Dellara Pty Ltd

Report for Modifications to Modified Preferred Project Overview Report

September 2011

Figure 2 Northern Face Typical Sections

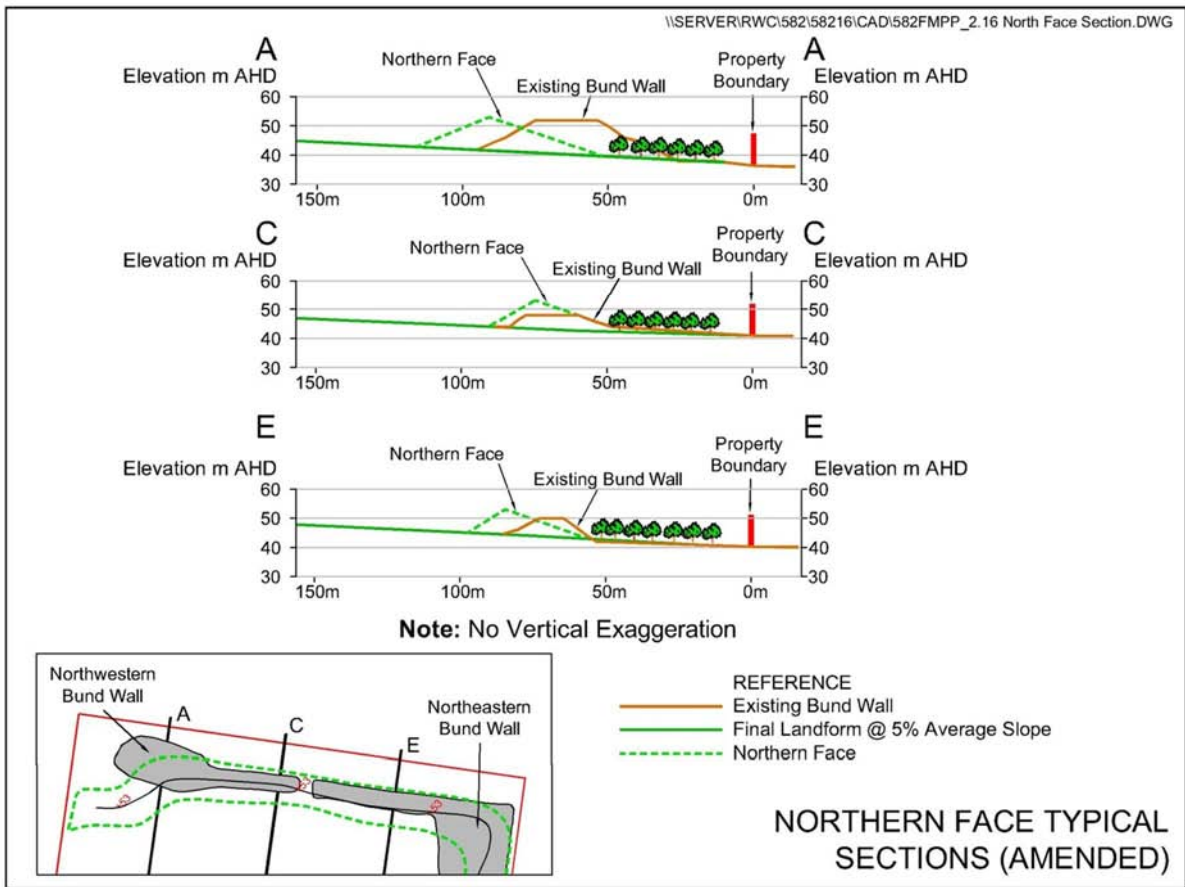
Figure 2 displays three representative sections through the northern face recording the profile of both the existing bund wall and the proposed northern face. Removal of the existing bund material north of the new northern face would occur during the site establishment period. At the completion of this earthworks program, the newly created northern face would have an elevation of approximately 53m AHD along its full length.

Figure 3 Deconstruction of the Northern Face

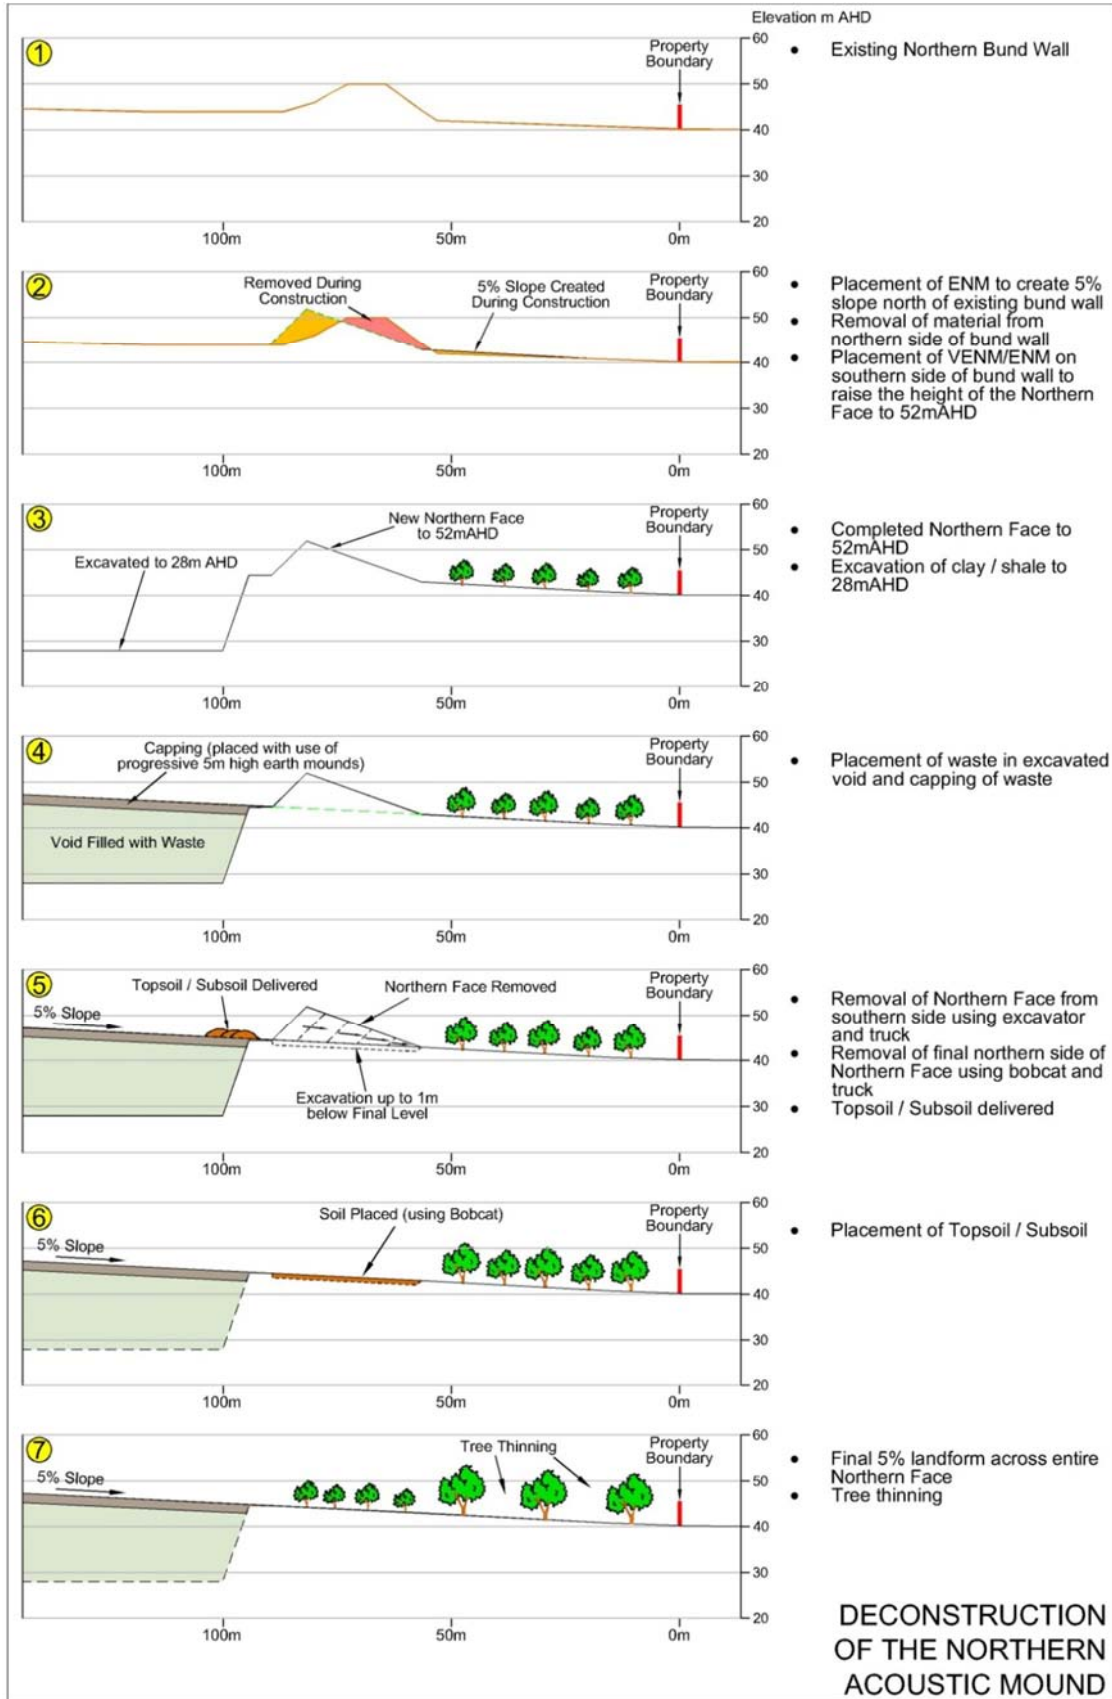
The existing bunds at the northern end will be modified to form the final northern face and to provide above that face an acoustic and visual bund for the first phase of the project to provide the necessary topographic barrier to control noise and visibility during rehabilitation of the site. They will then be removed during the project to provide a final landform which has an overall form similar to the pre-extraction landform. This process is illustrated in **Figure 3**.

Figure 4 Further Modified Final Landform with Northern Face – 5% Slope

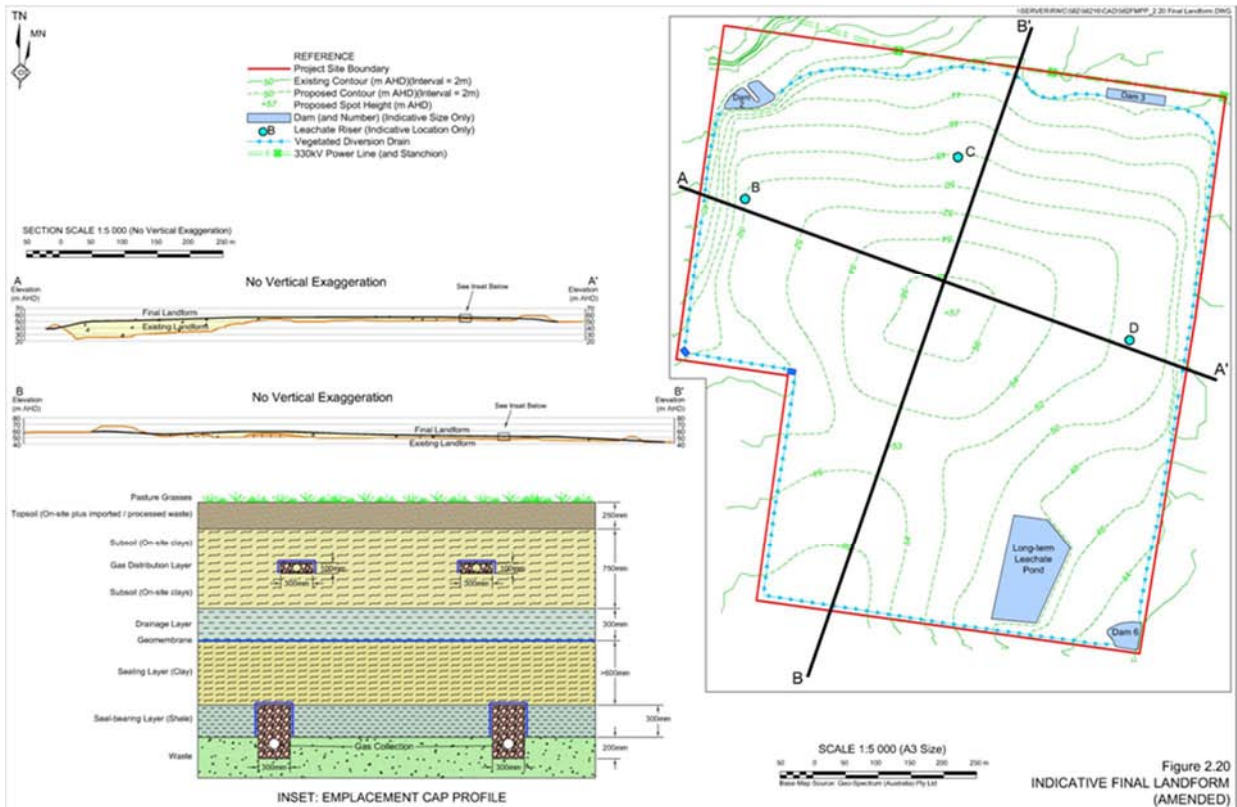
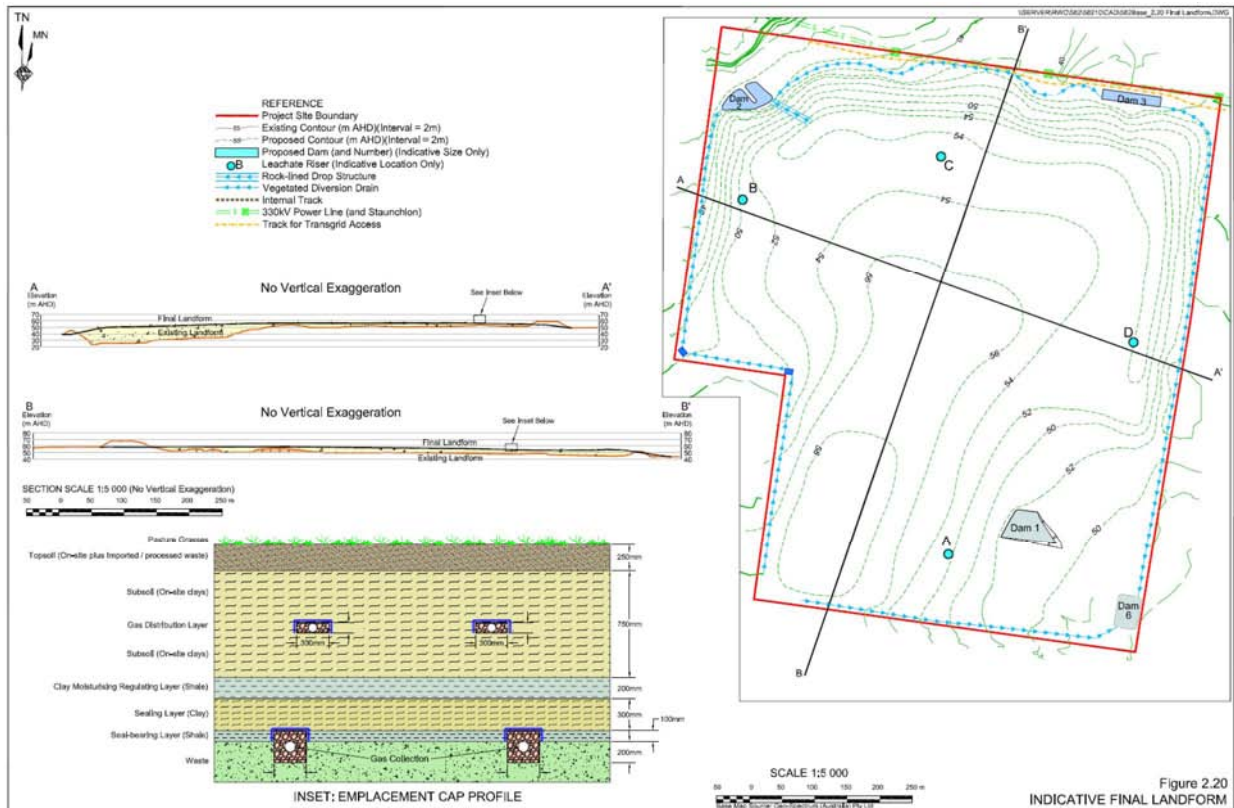
A new, lower final landform has been adopted. This will reduce the final elevation at the northern part of the site to approximately 44m AHD, 3-4 m above the pre-existing ground levels. The final landform of the site is illustrated in **Figure 4**, while **Figure 5** shows the previously proposed landform. **Figure 6** shows the difference in levels between the two landforms.

Figure 6 displays a north-south cross section of the final landform in comparison with the landform presented in the Modified Preferred Project Report (January 2011). The final landform would result in the creation of a gently sloping grassed knoll with an elevation of approximately 57m AHD, as shown in **Figure 4**.

Figure 7 Depth of backfill - Recycling and Re-processing Area

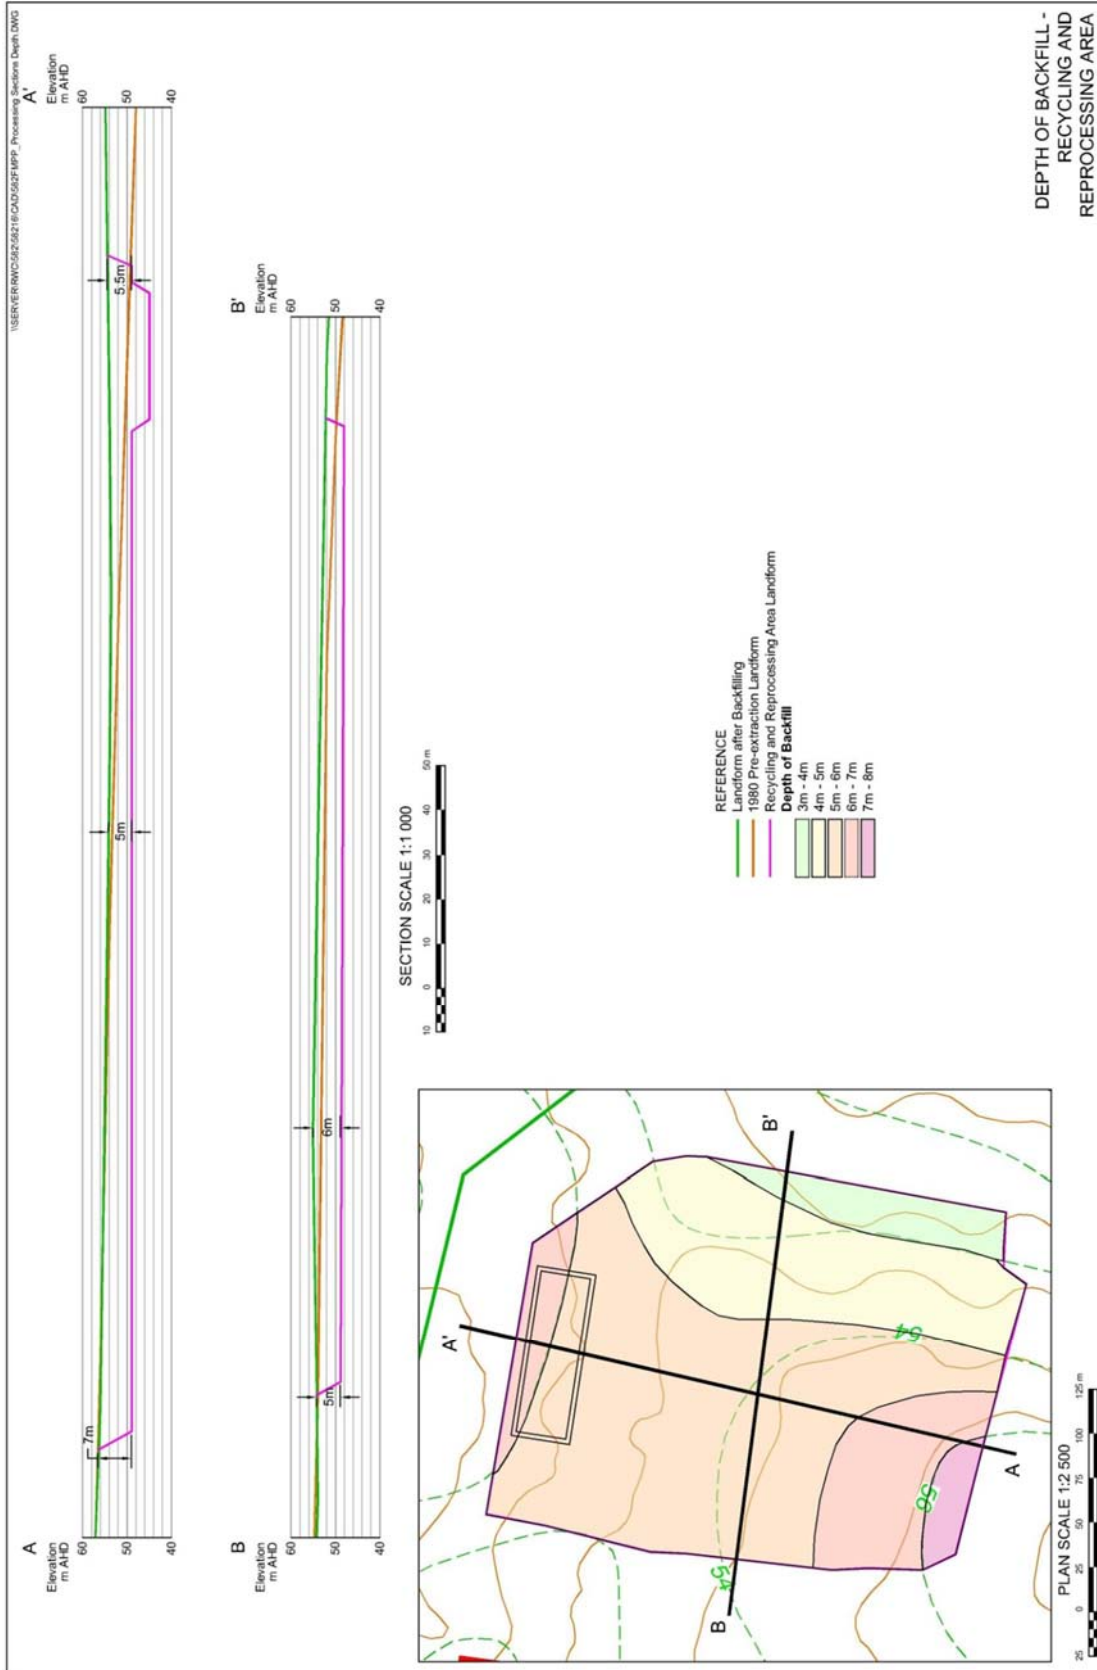
Figure 7 displays the extent of back fill within the former recycling and reprocessing area (Cell 4 in the MPPR), which is lower than previously proposed, because this area will be filled with VENM/clay/shale, rather than waste, to allow for future extraction of resources.

Figure 8 Comparative Final Landforms in Cross Section – North/South

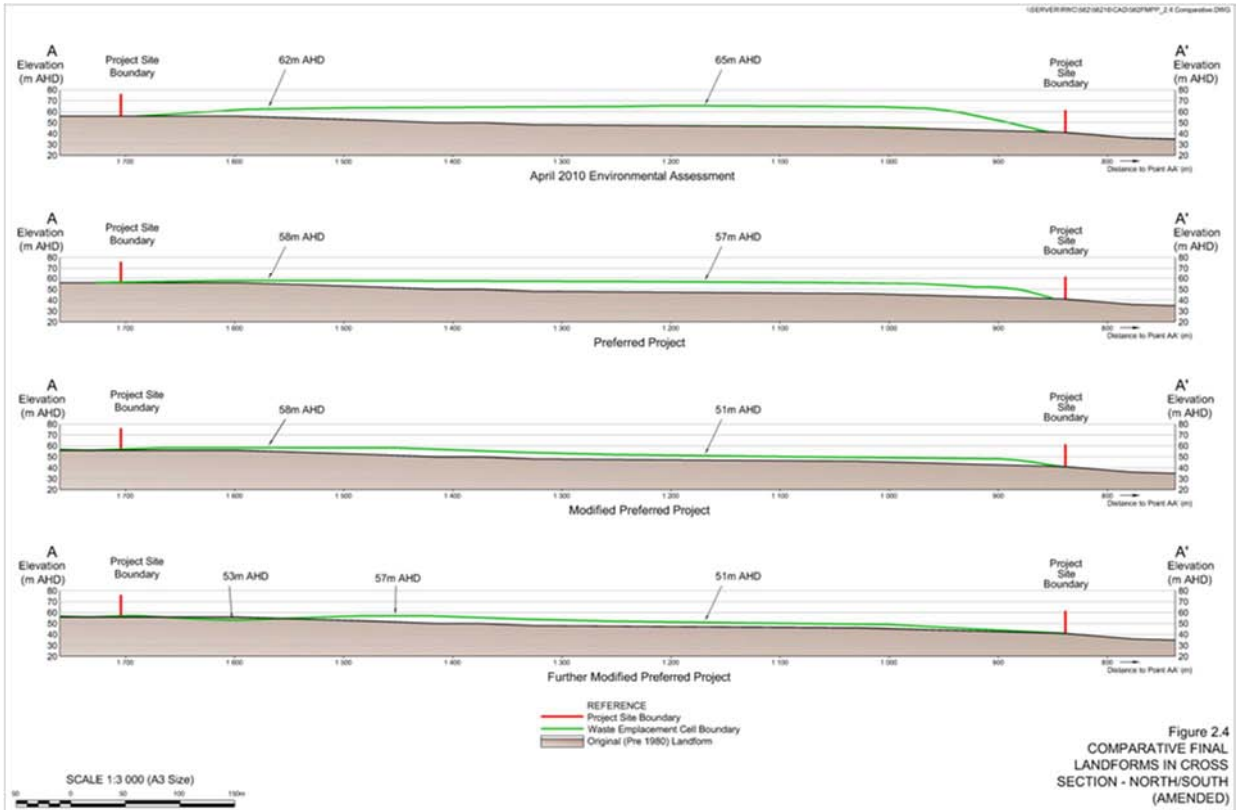
Figure 8 displays a north-south cross section of the final landform in comparison with the landform presented in the *Environmental Assessment* (April 2010), Preferred Project Report (July 2010) and the Modified Preferred Project Report pre-extraction landform (1980).

Figure 9 Recycling and Re-Processing Area

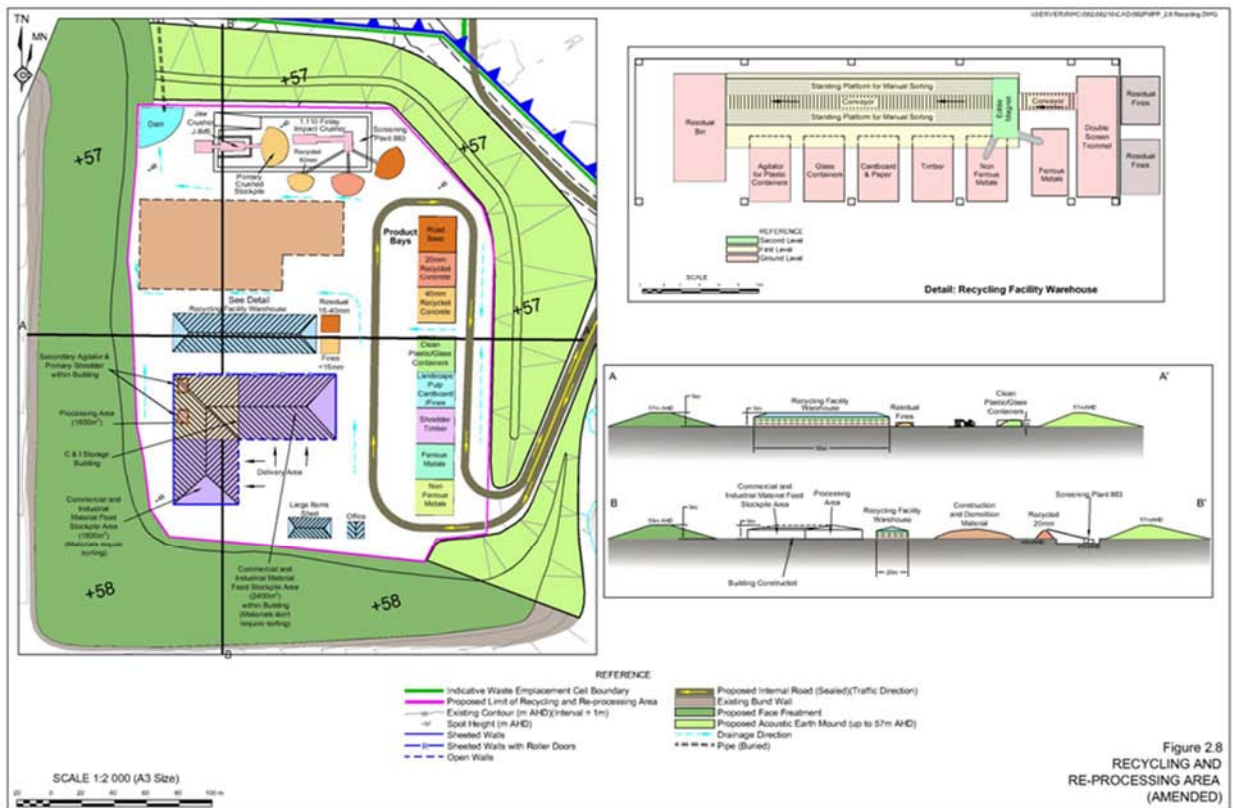
The C&I recycling component would comprise a recycling facility located within an 1 800m² building open only to the south – see detail on **Figure 9**. The C&I waste would be sorted by a combination of mechanical and manual sorting equipment together with mechanical cleaning.

Figure 11 Indicative MPP Site Layout

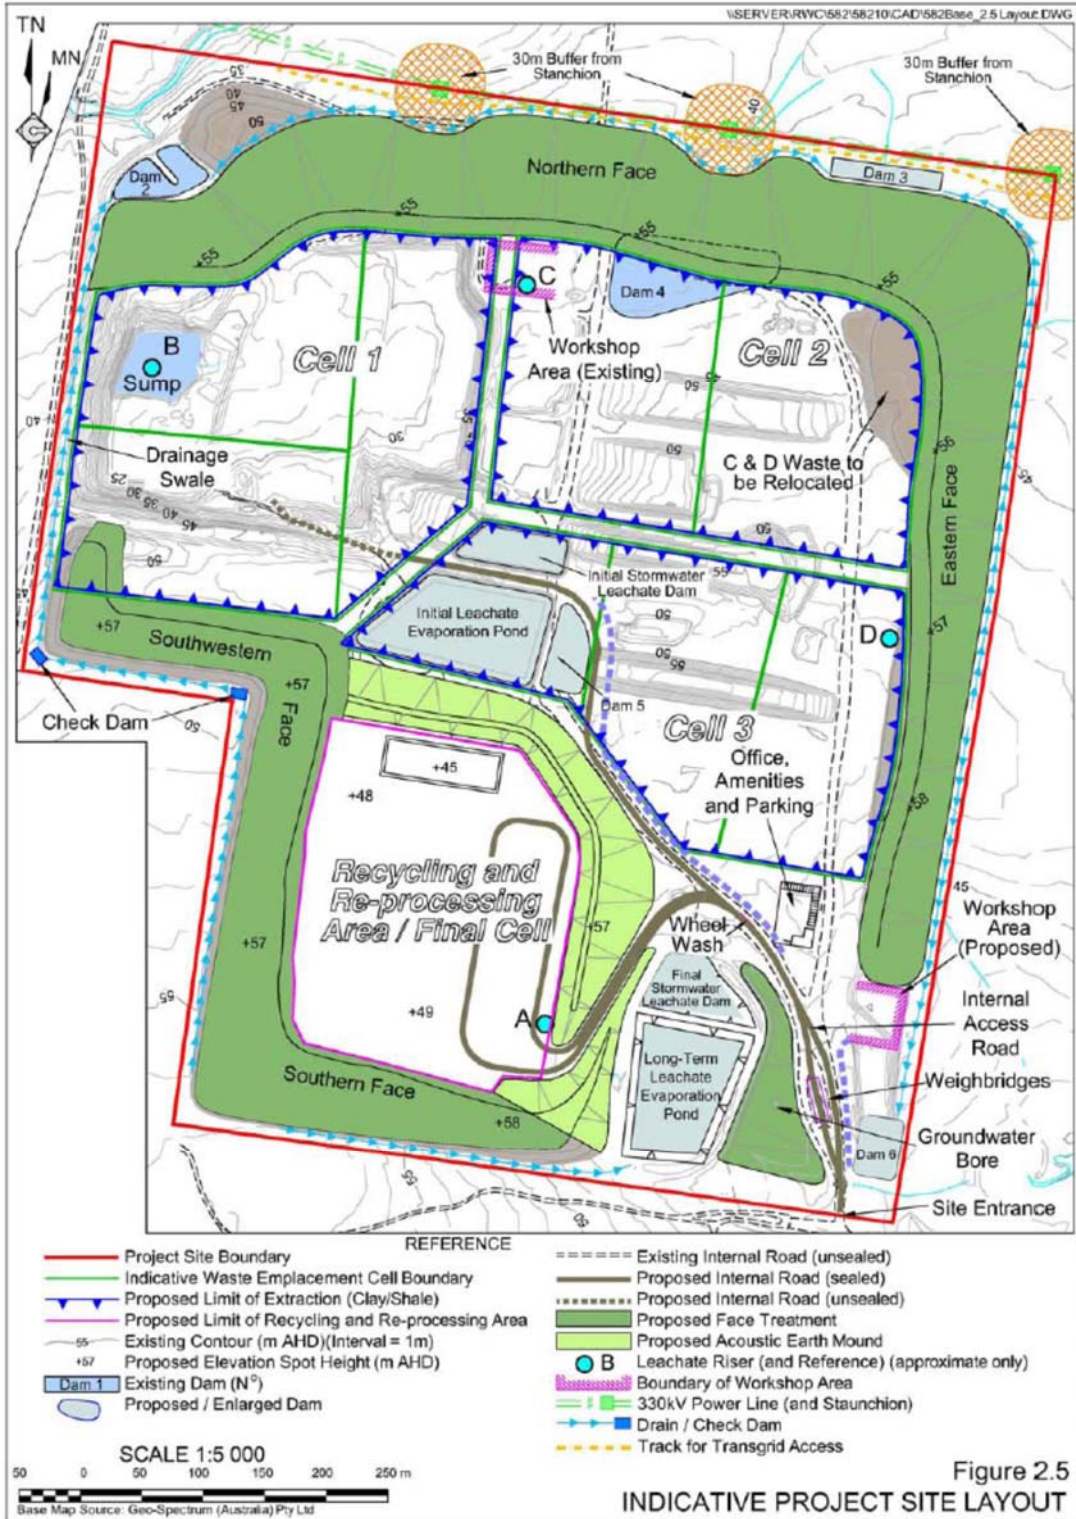
Figure 10 and **Figure 11** show the key stages of the project, for the FMPP and the MPP respectively.
